The Sizewell C Project

5.2 Main Development Site Flood Risk Assessment Addendum Appendices A-F Part 1 of 10

MAIN DEVELOPMENT SITE FLOOD RISK ASSESSMENT ADDENDUM APPENDICES

Plate 3.1: Locations of the temporary flow gauging stations

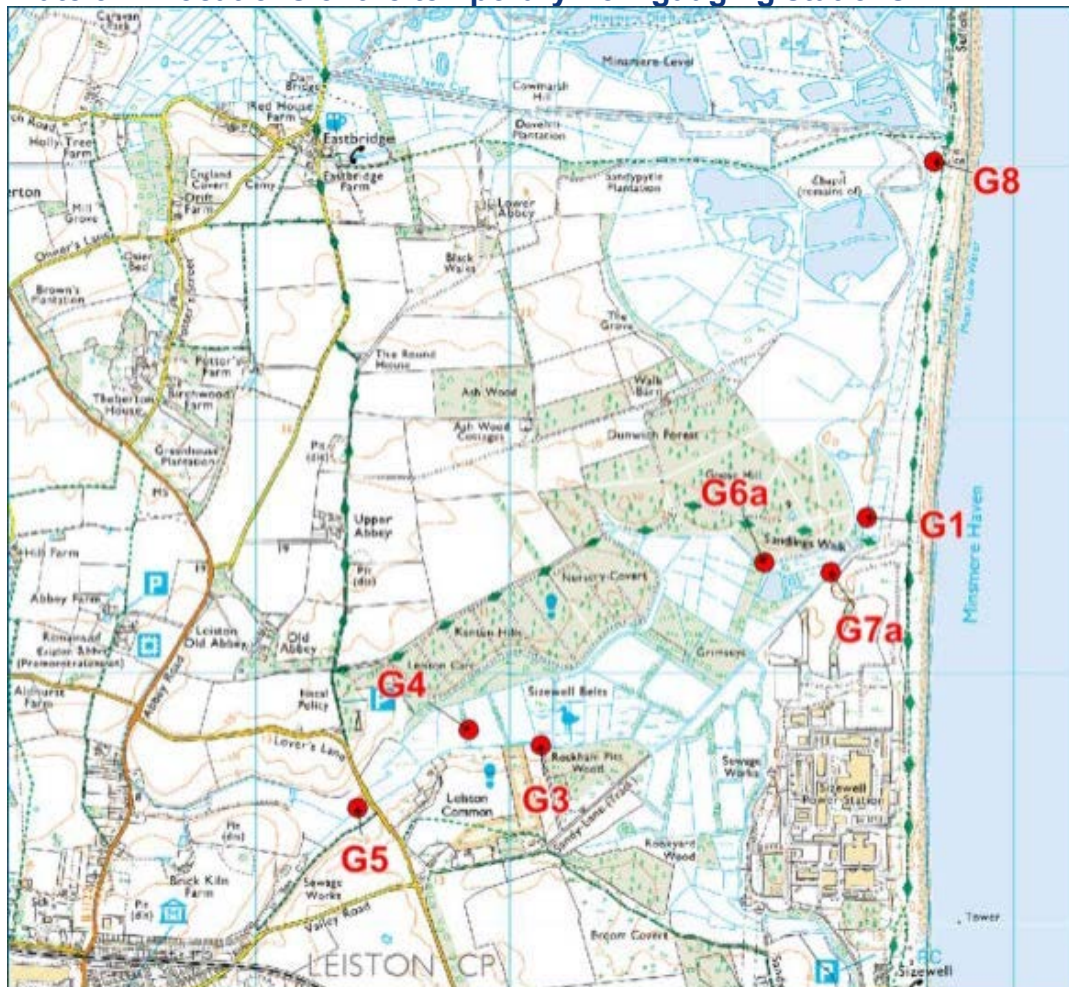
3.2.1 A number of comments were raised by the Environment Agency in relation to the availability of data from the temporary gauging stations installed as part of the Sizewell C project. The locations of these temporary gauging stations are presented in **Plate 3.1**.

Plate 3.2: G5 temporary gauging station recorded flow and stage data from 2013 – 2019

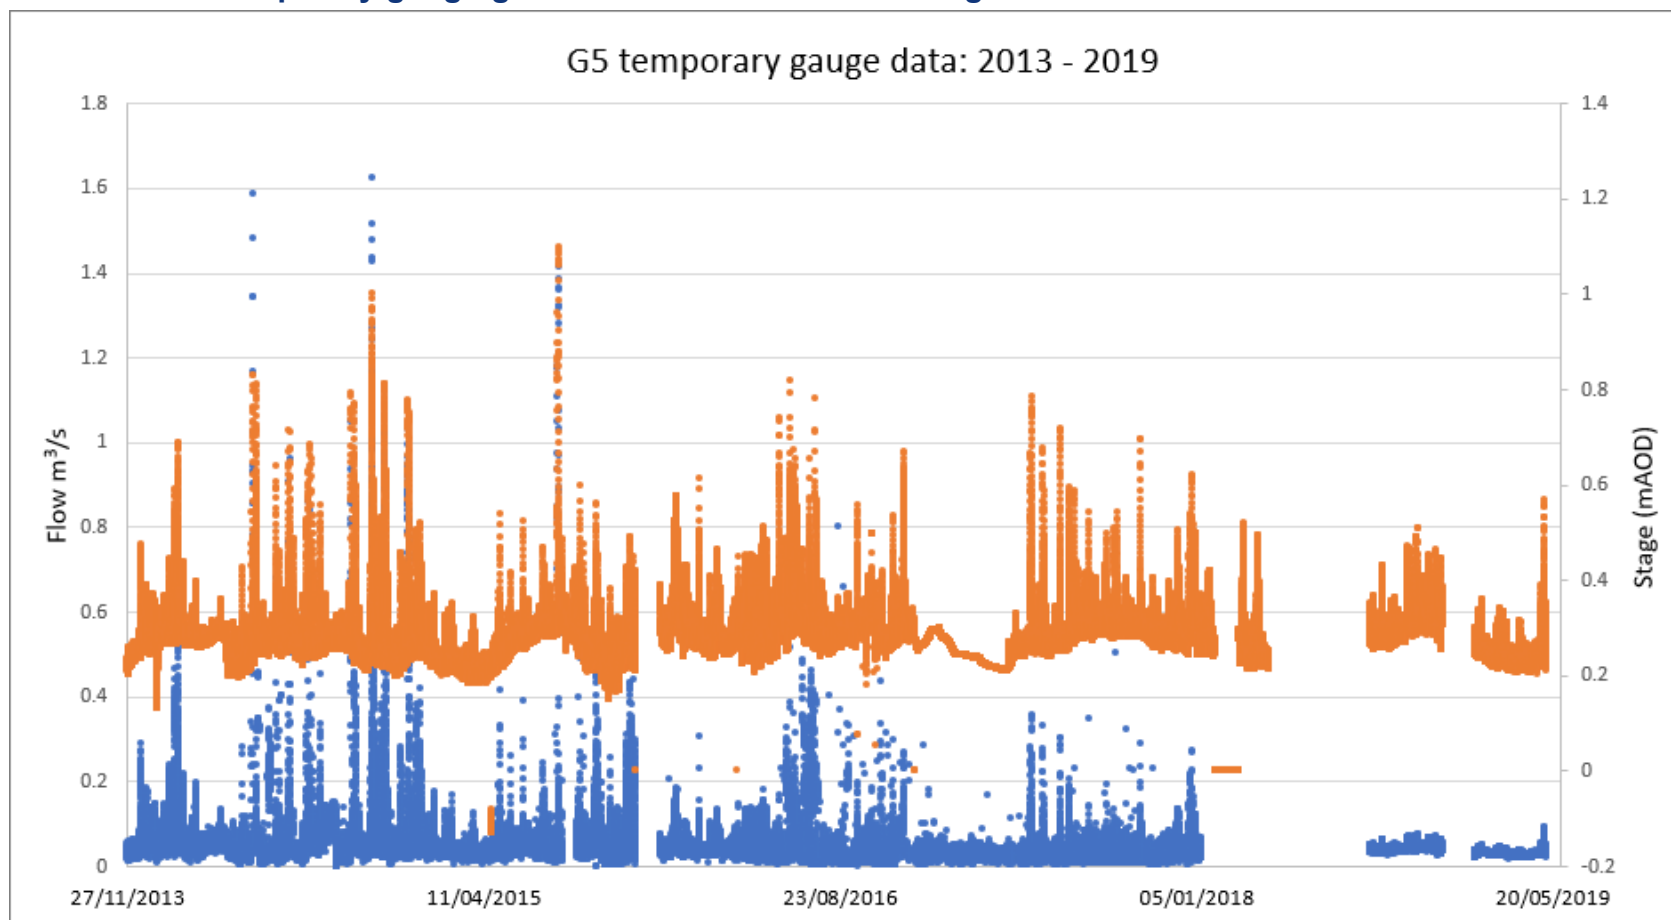
3.2.11 As noted above, an additional time-series dataset has been made available for the G5 temporary gauging station extending the period of record from November 2013 to July 2019, i.e. just short of 6 years (**Plate 3.2**).

3.2.12 In line with the Environment Agency comment, it was indicated that the extended record show in **Plate 3.2** should provide additional value and improved confidence to the POT data series and the derivation of QMED using the G5 temporary gauging station dataset.

Plate 4.1: Corrected alignment of HX line around the SSSI crossing

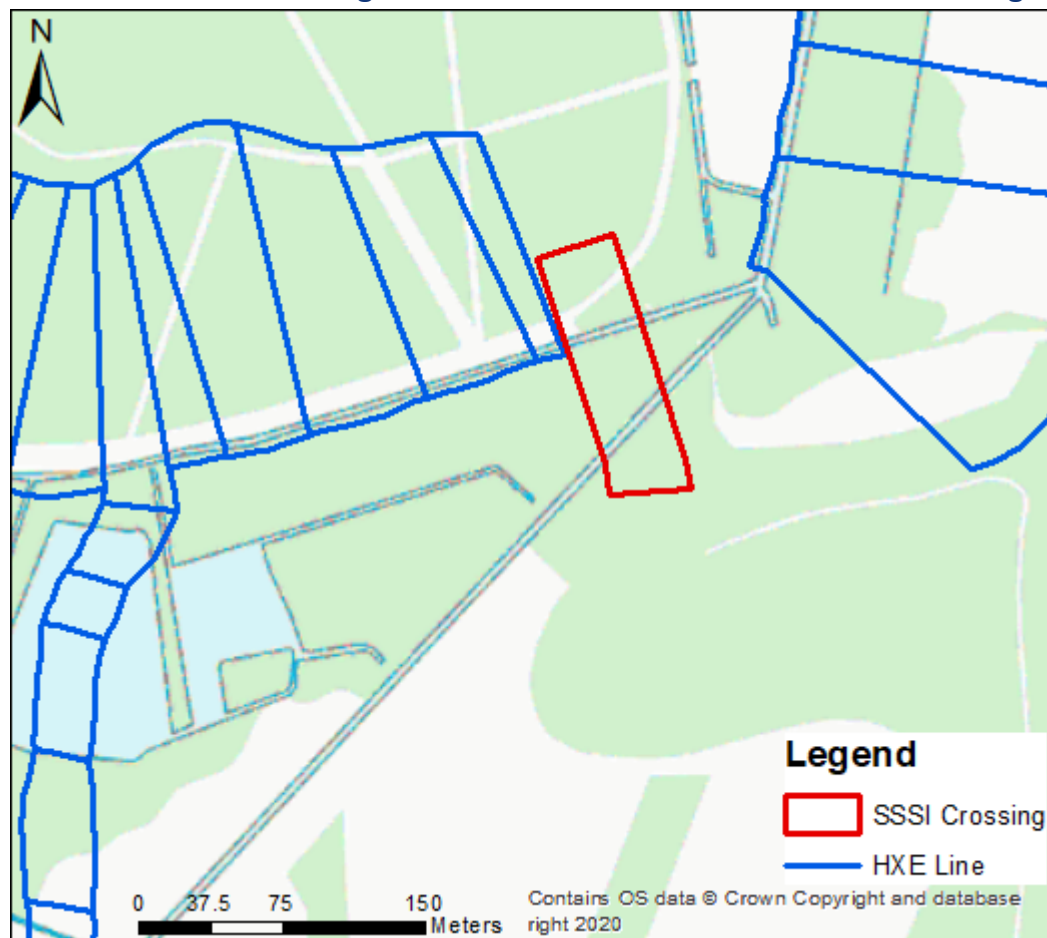
“The SSSI crossing (2d_zsh_SSSI_crossing_v1_R) position does not appear to line up well with the positioning of the HX lines (2d_bc_hxe_Sizewell_050). Consequently a portion of the deck is not raised as expected and lies within the deactivated area of the 2d model domain.”

- 4.2.2 Model schematisation was updated in line with the comment above by re-aligning the HX and CD lines within the HXE layer in the 2D Tuflow model domain to ensure that the footprint of the proposed development is more accurately represented. The corrected alignment is shown in **Plate 4.1**.
